Consideration of a Master Plan Amendment application for modifications to the Twin Creeks Master Plan, including realignment to an off-street pathway and revising the land use designation to permit high-density residential development with limited ground floor commercial uses. The 1.62 acre site is located at the intersection of Twin Creeks Crossing and Boulder Ridge Street and is identified on the Jackson County Assessor's map as 37S 2W 03CA, Tax Lot 1500. **Applicant:** Smith Crossing, LLC; **Agent:** Scott Sinner Consulting, Inc.

Associated Files: CPA-23002, ZC-23002, SPAR-23001

**PLANNING DEPARTMENT SUPPLEMENTAL FINDINGS OF FACT
AND CONCLUSIONS OF LAW
File No.: MP-23001**

Figure 4 Site Plan

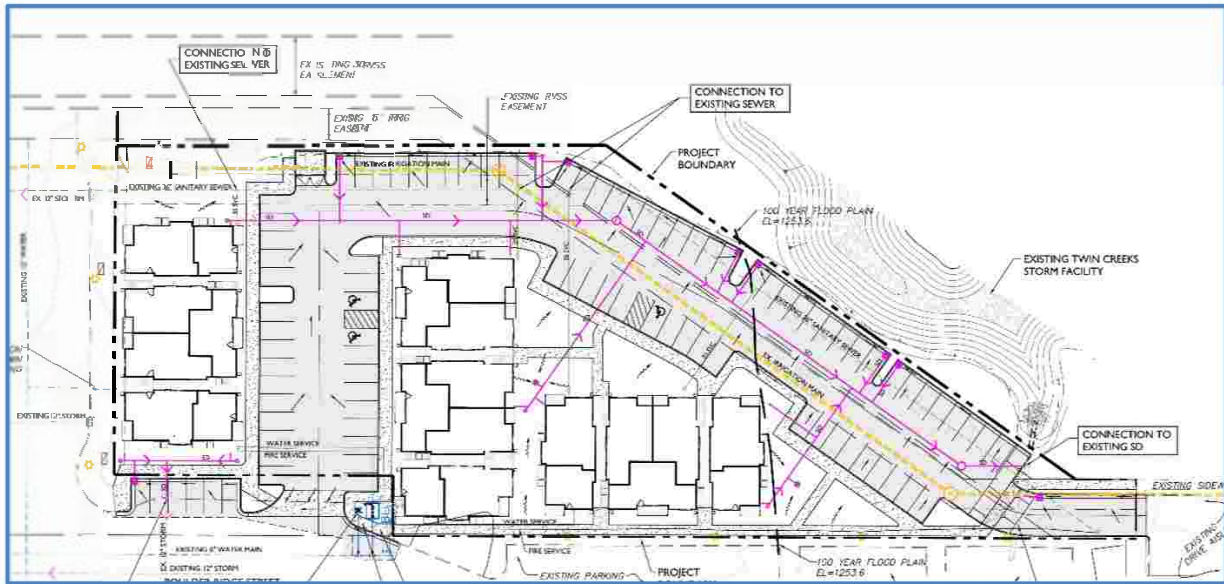
Staff recommends Condition of Approval No. 1 that requires the applicant to revise the site plan showing commercial floor area on the publicly visible areas of Building 1,

including the west elevation along the Boulder Ridge Street frontage and north elevation along the entire Twin Creeks Crossing frontage.

The proposed location, as depicted on the Site Plan (Attachment "B-1"), is abutting the west property boundary of the subject property. There is an existing three (3) foot wide landscape buffer between the path and the parking area on the adjacent property that will provide a vegetative buffer to the pedestrian path.

1. Prior to the issuance of any building permits, the applicant shall submit a revised site plan that depicts the ground floor of Building 1 providing leasable commercial floor area along the entire frontage of Twin Creeks Crossing and the frontage of Boulder Ridge Street.

2. Prior to the issuance of building permits, the Applicant shall provide a copy of a signed and recorded easement, as necessary, to allow for public access to the realigned pedestrian accessway.

Figure 7 Proposed path circulation

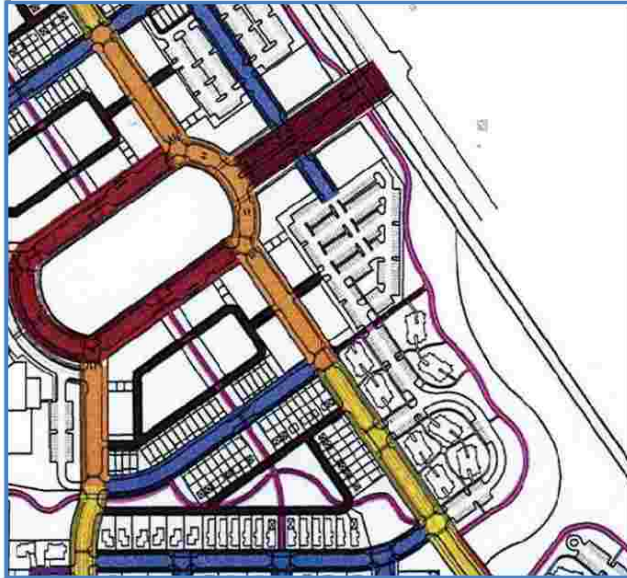
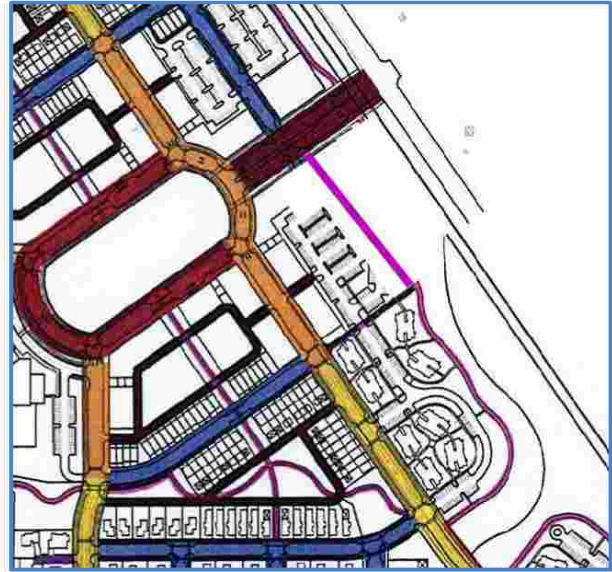
Staff Comment: The Twin Creeks Master Plan identifies an off-street public accessway along the western boundary of the subject property. The path location identified in the master plan is along Griffin Creek, adjacent to an open space area that was modified in 2014-2016 to mitigate floodway hazards on the Twin Creeks Master Plan area. Due to the steep grades and the lack of pedestrian crossing at the path terminus at Twin Creeks Crossing, the applicants propose relocating the pedestrian access along away from the eastern property boundary, terminating at the intersection of Twin Creeks Crossing and Boulder Ridge Street. As a condition of approval, the pedestrian accessway must be installed in accordance with the standard identified in Master Plan Exhibit 12 and provide an easement for public access

Figure 12 Revised Civic and Commercial Plan

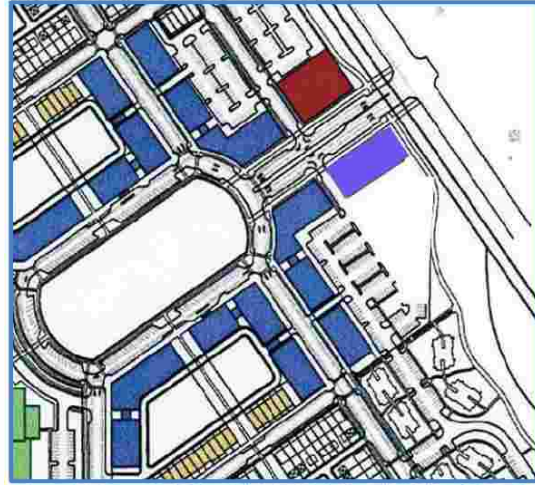
Staff Comment: The property is identified as a location for destination retail and professional office on Civic and Commercial Plan, (Exhibit 37 of Master Plan).
